Product information brake shoe set | HELLA

8DB 355 005-111 / R1301

Different types

Product comparison

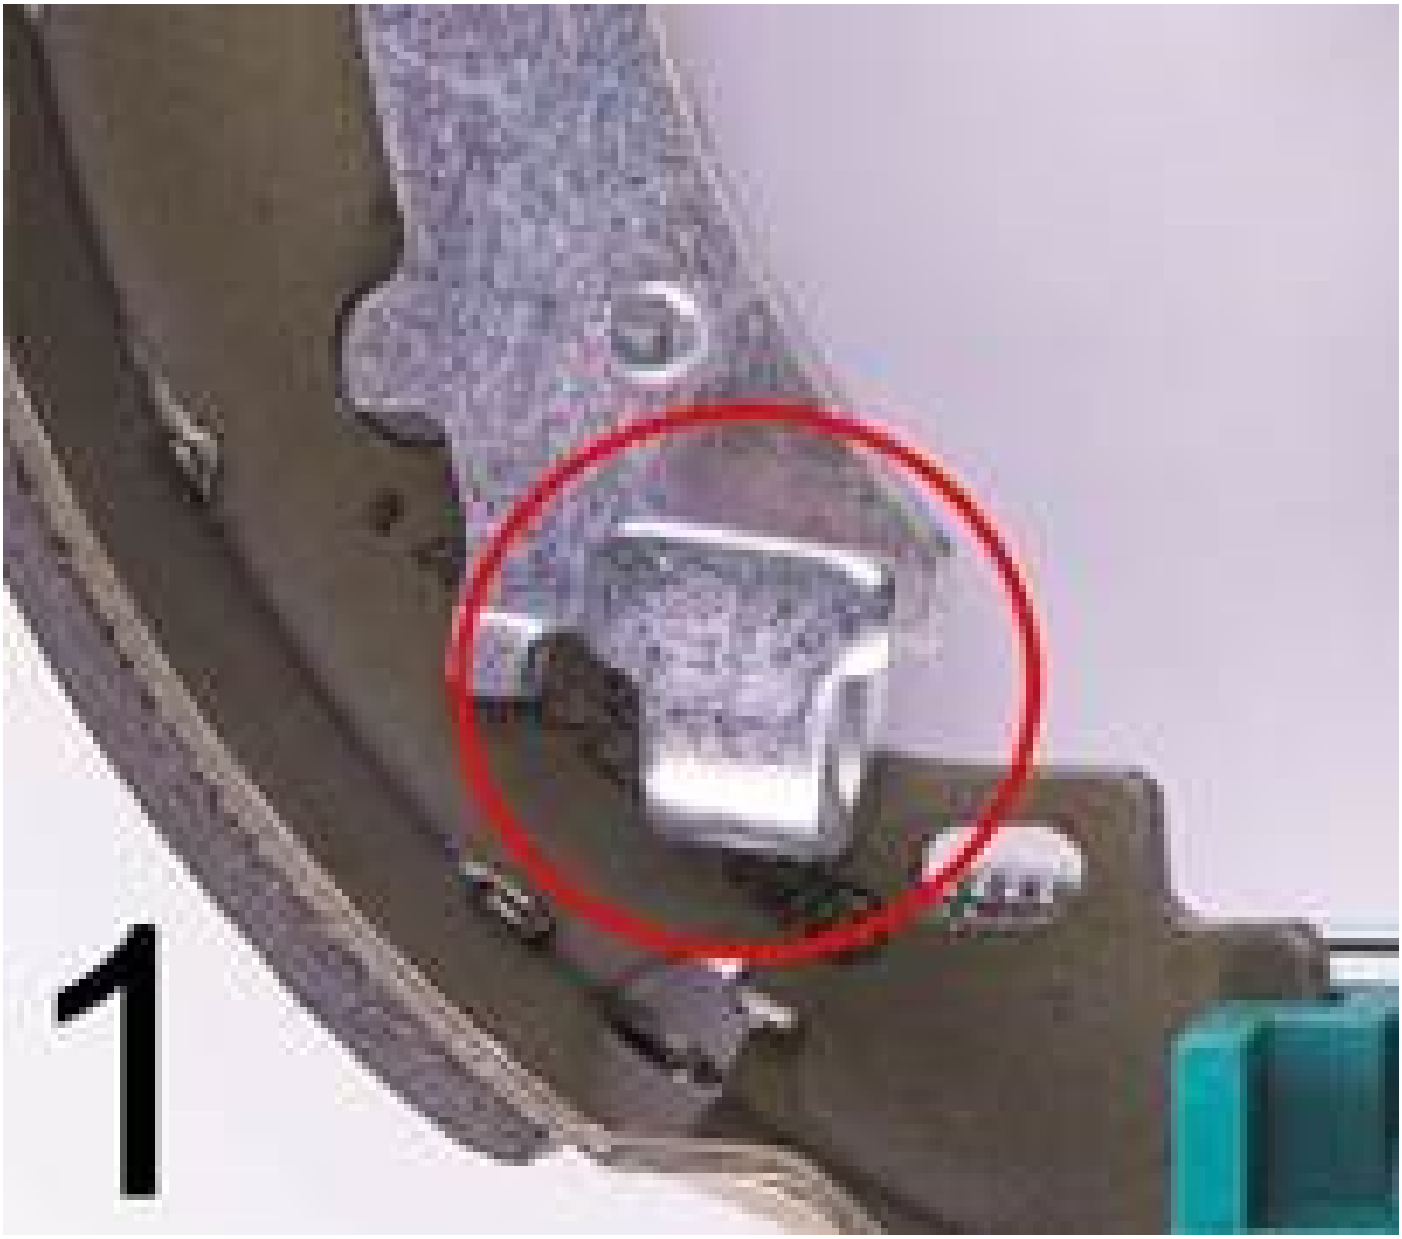
The design of the handbrake lever on the brake shoe is different in comparison with the first version, or rather the attachment element for the handbrake cable is configured differently as can be seen in the pictures. This amended installation situation has no effect on the installation and function of the handbrake cable. Both articles can be used within the framework of repair activities.
